Technical Service Information

MITSUBISHI F4A40/50 SERIES HARSH DRIVE ENGAGEMENT OR 4-3 DOWNSHIFT AND OR HARSH OR FLARED 3RD GEAR UPSHIFT

Figure 1

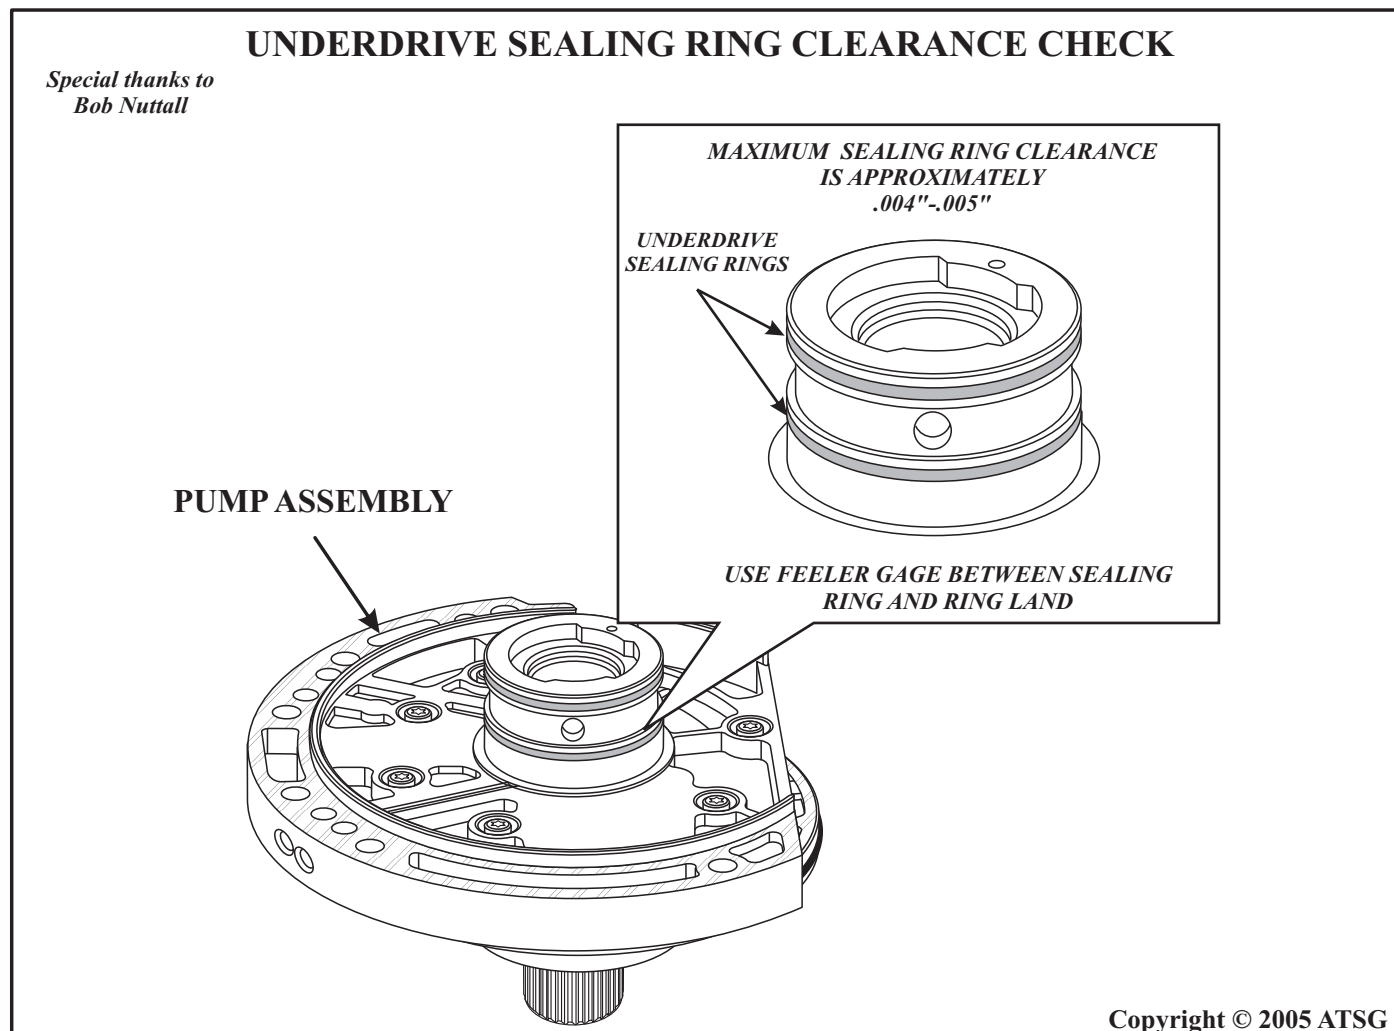
CORRECTION: Refer to Figure 1 to identify the Underdrive Clutch Sealing Rings. Using a feeler gage ensure that there is no more than .005" clearance between the sealing ring and the sealing ring lands. Repeat the same process for the Overdrive Clutch Sealing rings as shown in Figure 2. Replace the Pump stator or Rear Cover as necessary. **NOTE: Refer to Figure 3 and notice the "R-14" that is cast into the Pump Cover/Stator Support and Rear cover. This identifies a new design part which is made out of stronger material reducing ring land wear.**
